ADDENDUM NO. 1

April 23, 2024

Whiteland Community High School Phase 2A
300 E. Main Street
Whiteland, IN 46184

This Addendum consists of Pages ADD 1-1 through ADD 1-2 and attached Specification Sections 01 21 00 – Revised Contract Allowances, Logistics Plan, Guideline Schedule, and Lancer Associates Architecture Addendum No. 1, dated April 23, 2024, consisting of 63 Pages, Specification Sections 11 68 33 – Field Events & Athletic Equipment, 32 18 23 – Track Surfacing Latex System, 32 31 13 – Chain Link Fencing and Gates, 33 14 17 – Site Water Utility Service Laterals, 33 42 00 – Stormwater Conveyance, and Drawings 100, 210, 302, 303, 400, 401, 402, 403, 500, 501, 600, 601, 700, 900, 901, 902, 903, 904, 1004, L101, L102, L201, L202, L402, ES102, ES103, and ES301.

JOB No.	DRAWN	KLF	CHECKED	TEN	Transportation & Development Consultants 1514 THE AVENUE, SUITE 200C, WILLOW PARK, ONTARIO M2H 3G9
DATE	APRIL 02, 2024	DESIGNED	APPR.	G.JI	
					SHEET 401

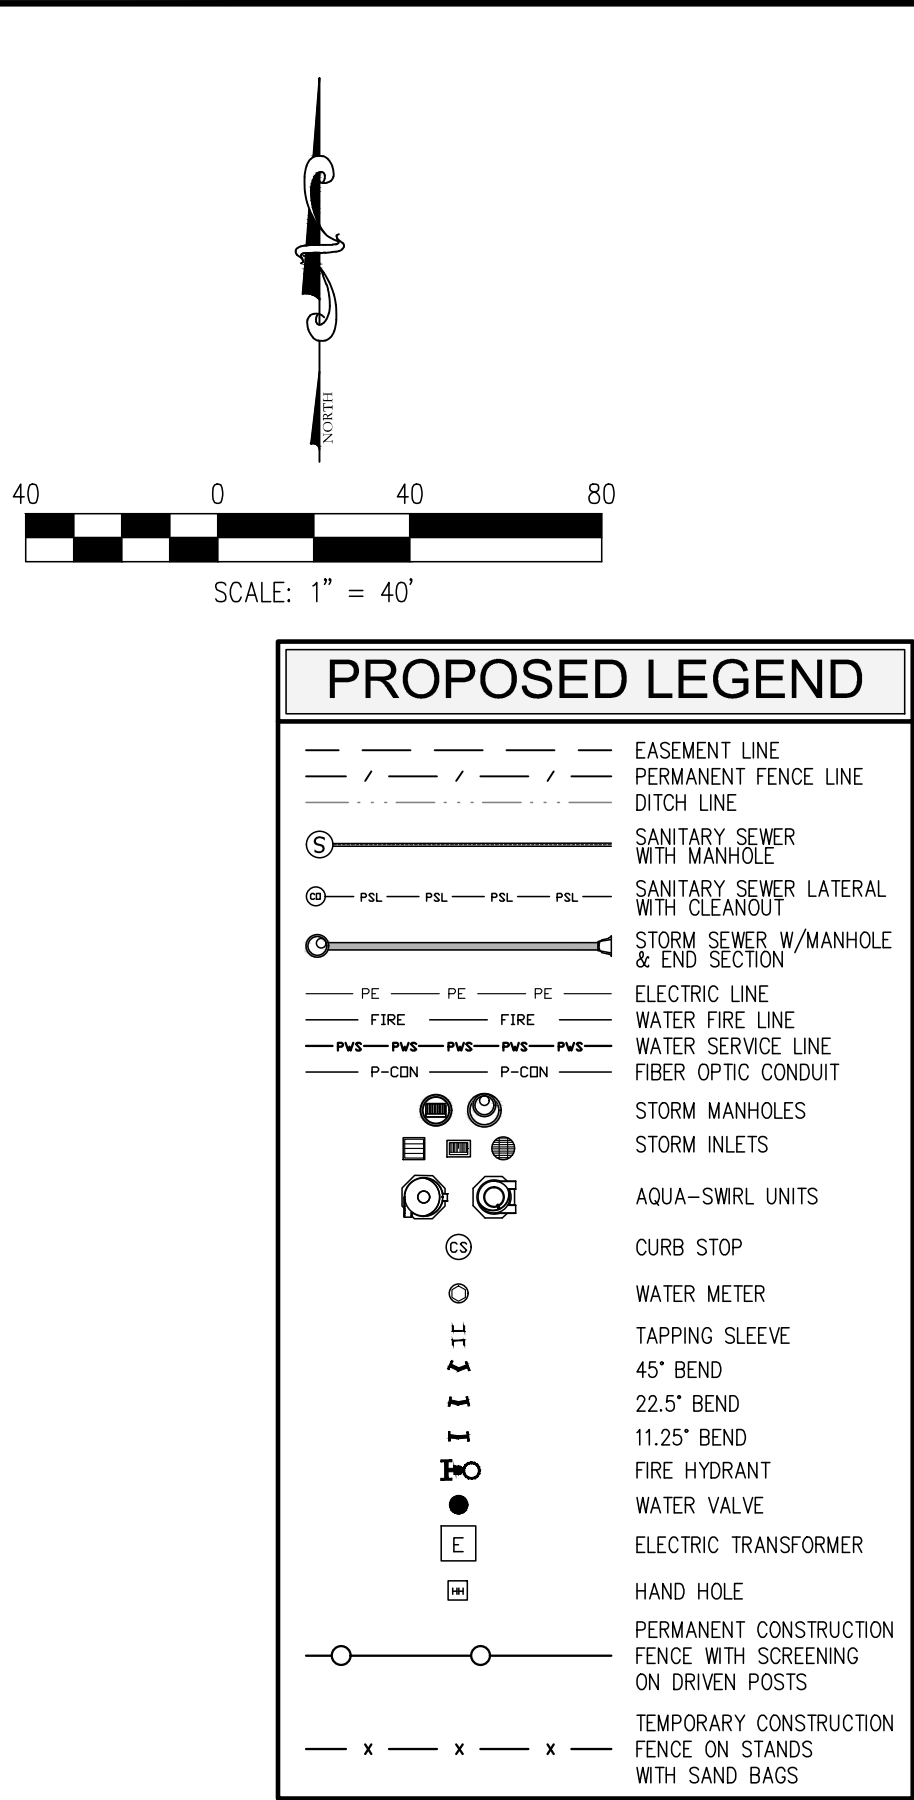
- o Revised Storm Culvert Data Table to indicate animals guards are required in the pipe end sections for Str. No. 80.

- o Revised Storm Sewer Structure Table to indicate that a concrete headwall with animal guard is required for Str. No. 81 instead of the pipe end section previously shown.

SHEET 402

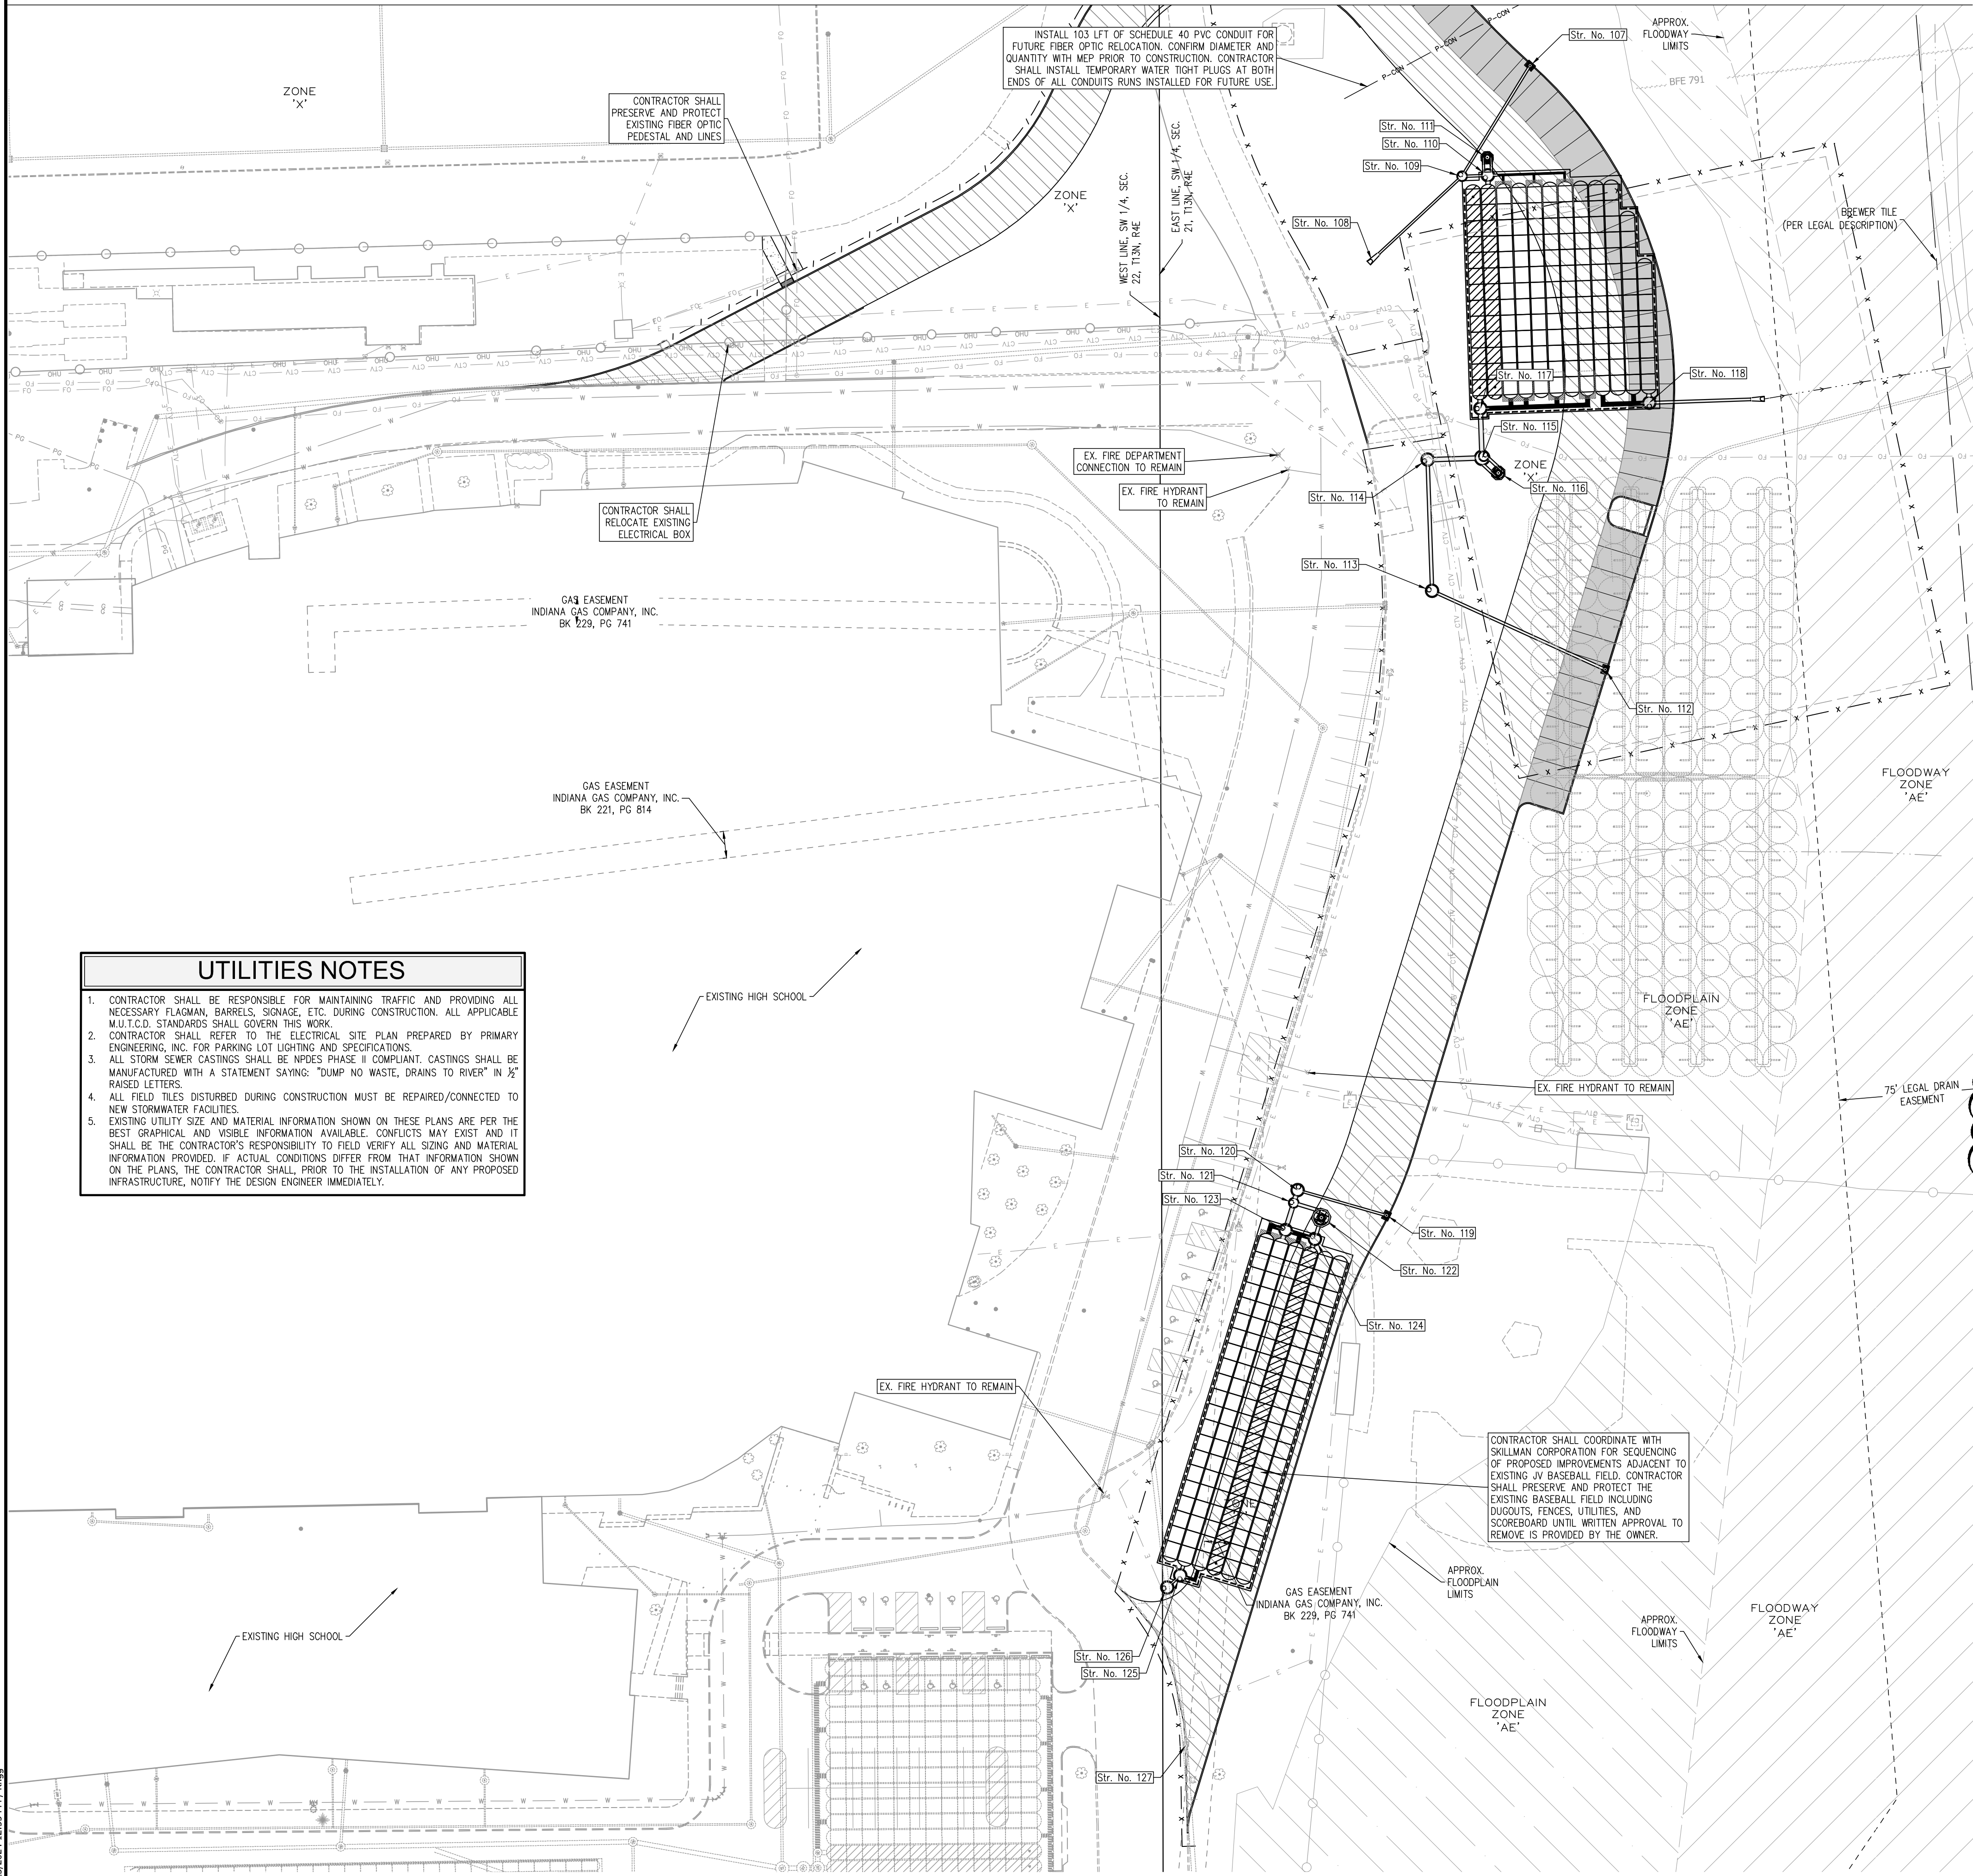
- 8. Utility Plan (sheet 402):
 - o Revised to include 6 LFT of Neenah R-4999-DD trench drain to replace drain removed in the existing parking lot north of the football field.

- o Revised Storm Culvert Data Table to indicate that one (1) concrete pipe end section and one (1) concrete headwall is required for Str. No. 104 instead of two (2) concrete pipe end section as previously shown. Storm Culvert Data Table was also revised to indicate that animal guards are required.

- o Revised Storm Sewer Structure Table to indicate that animal guards are required in the pipe end sections for Str. No. 102, 103, 105, and 106.
- 9. Utility Plan (sheet 403):

DRAINAGE PLAN

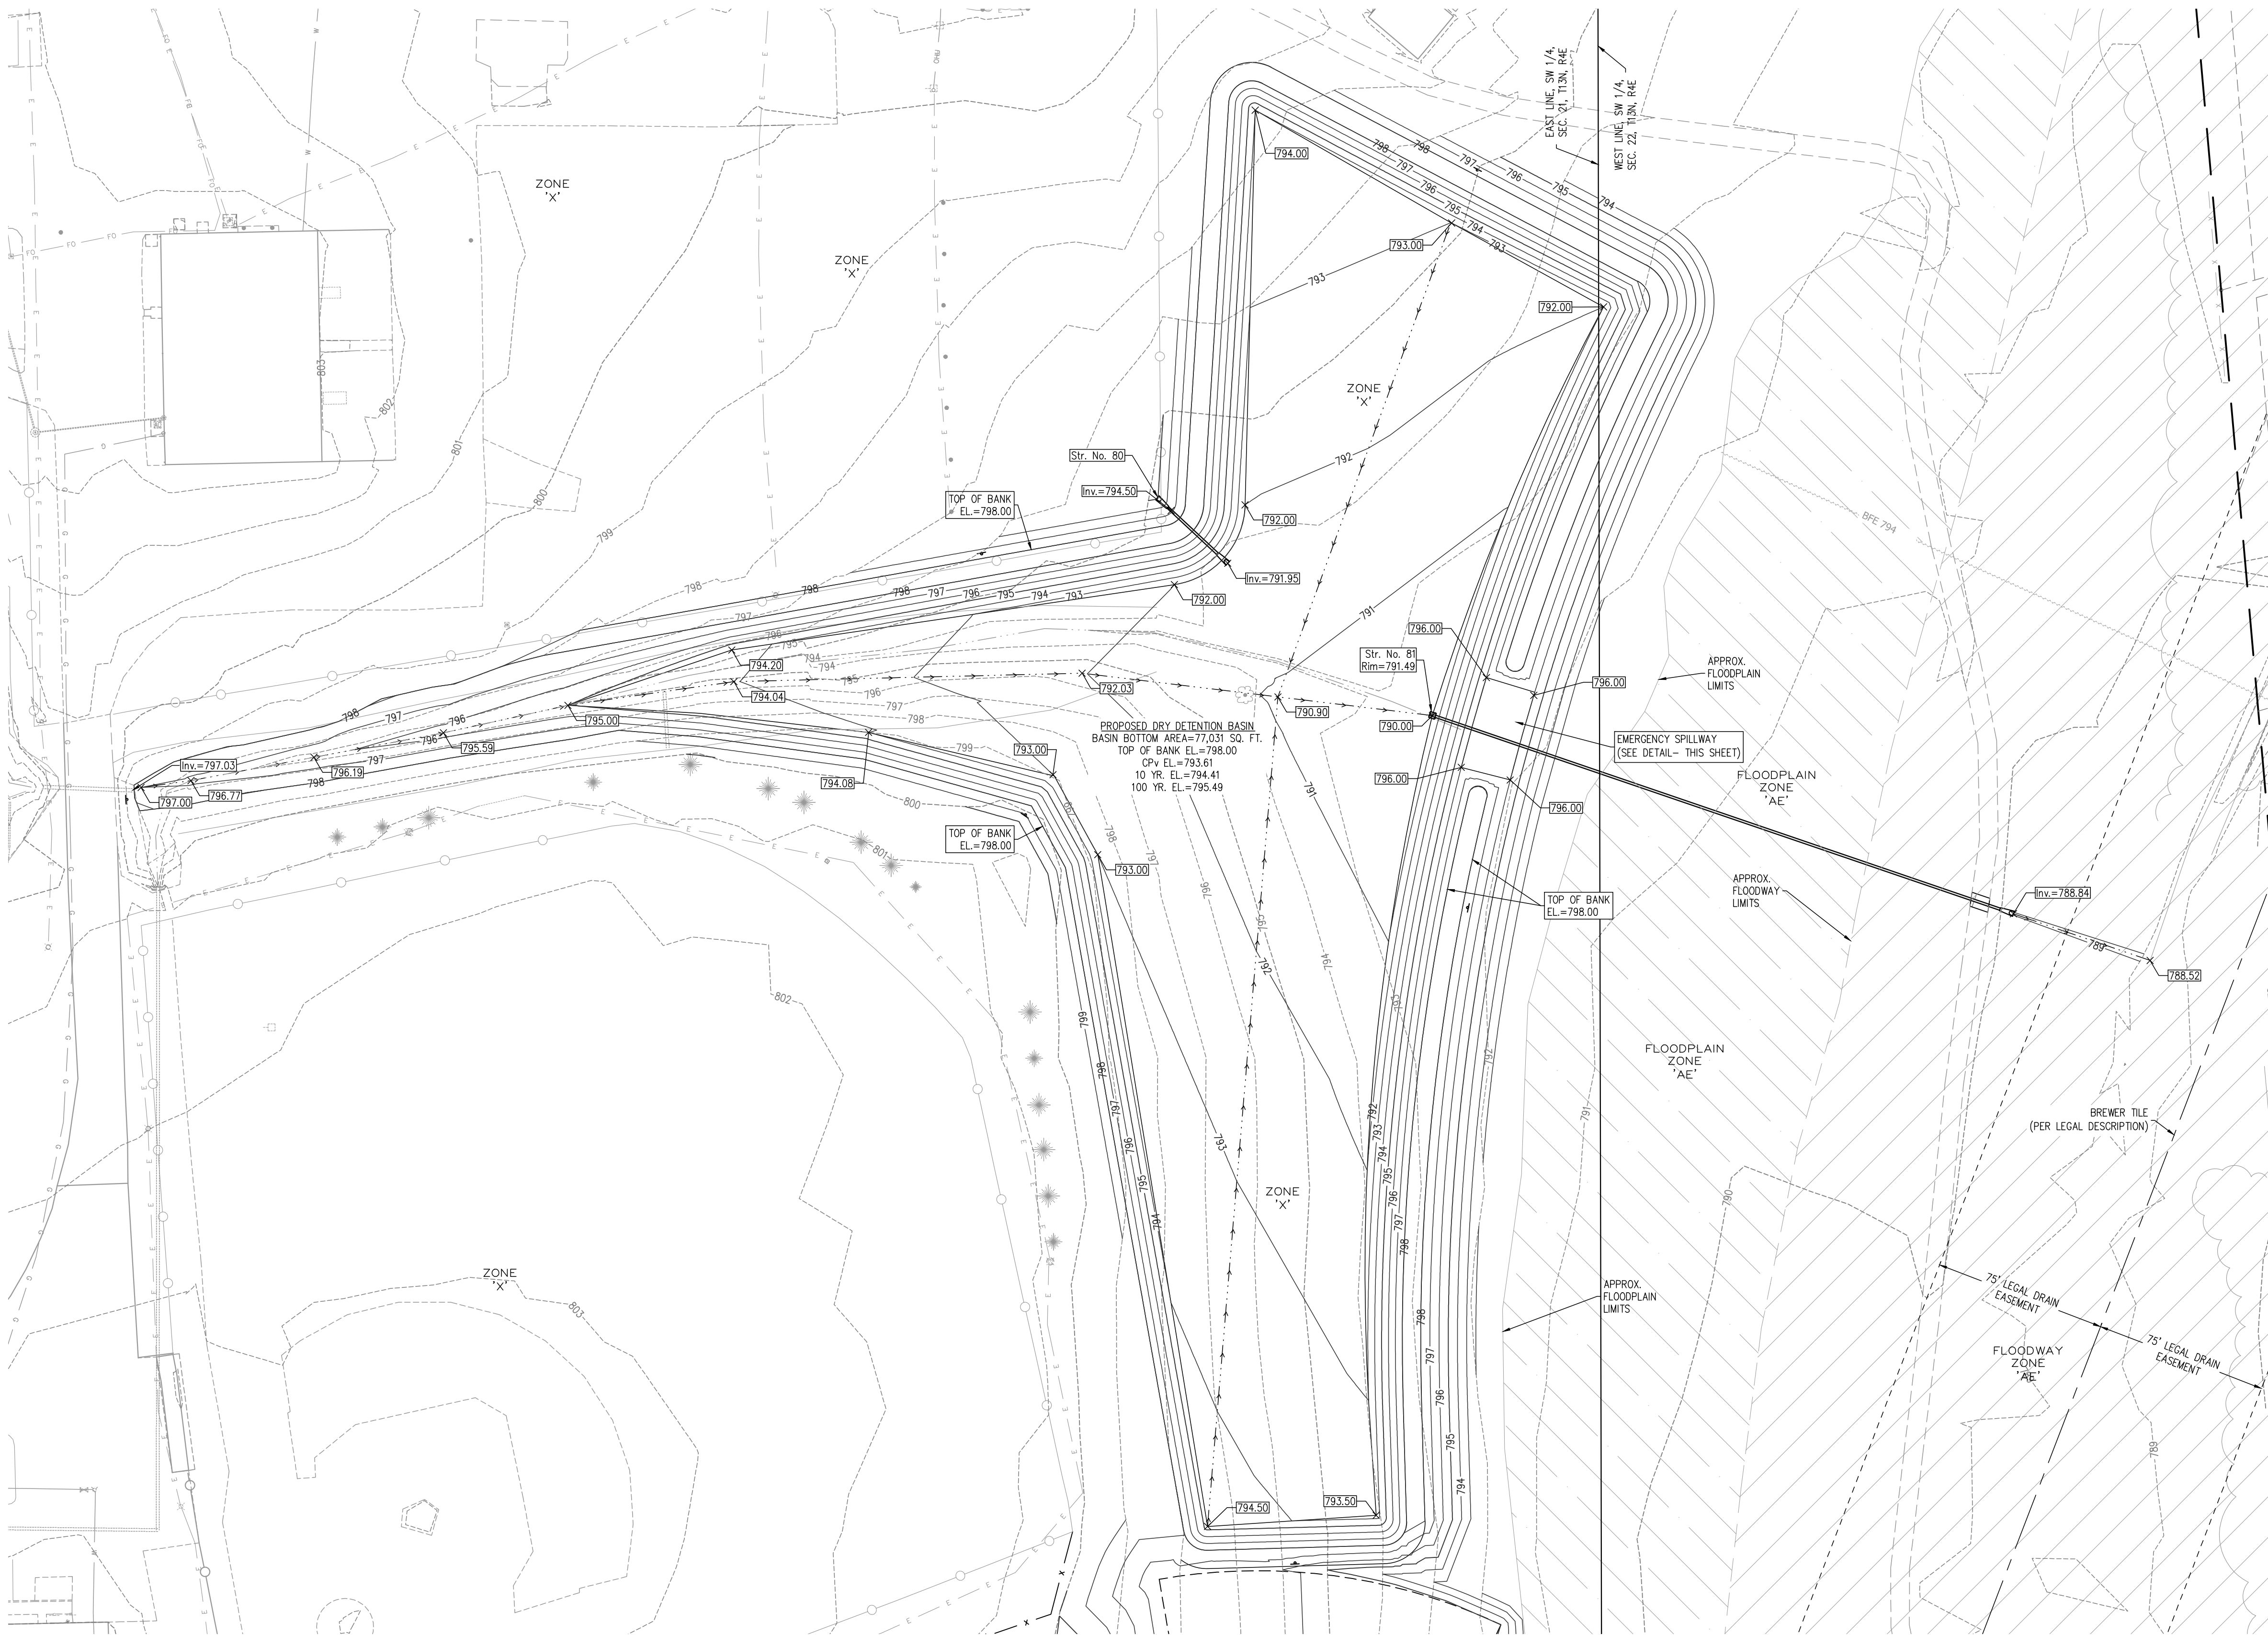
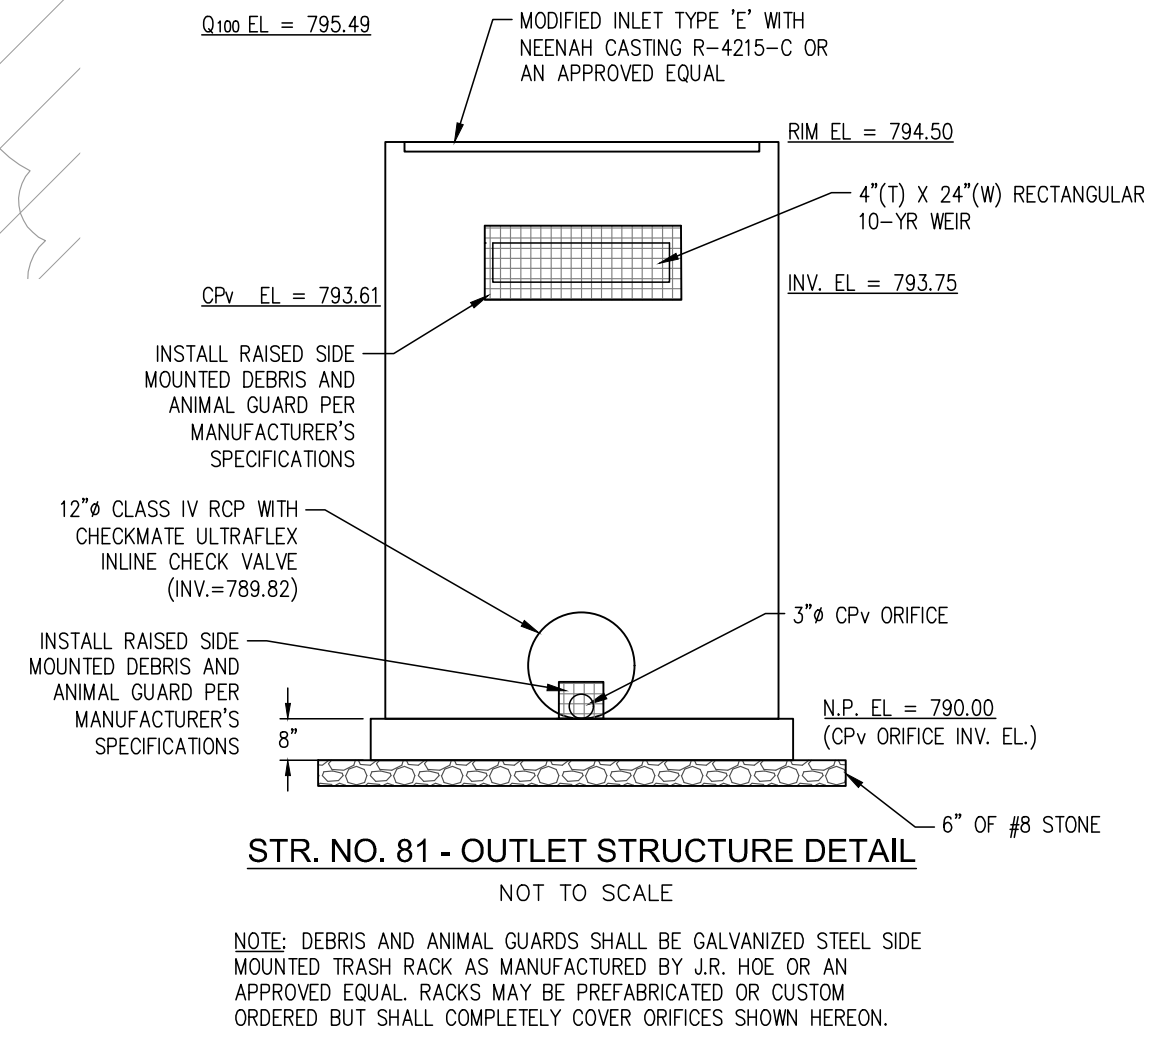
- 12. Drainage Plan (sheets 600-601):
 - o Added detention pond warning sign detail.
- 13. Sanitary Plan and Profile (sheet 700):
 - o Revised sanitary sewer profiles "SS-A" and "SS-B" to include sanitary lateral connection from tennis building lateral and to show proposed domestic water service crossing.
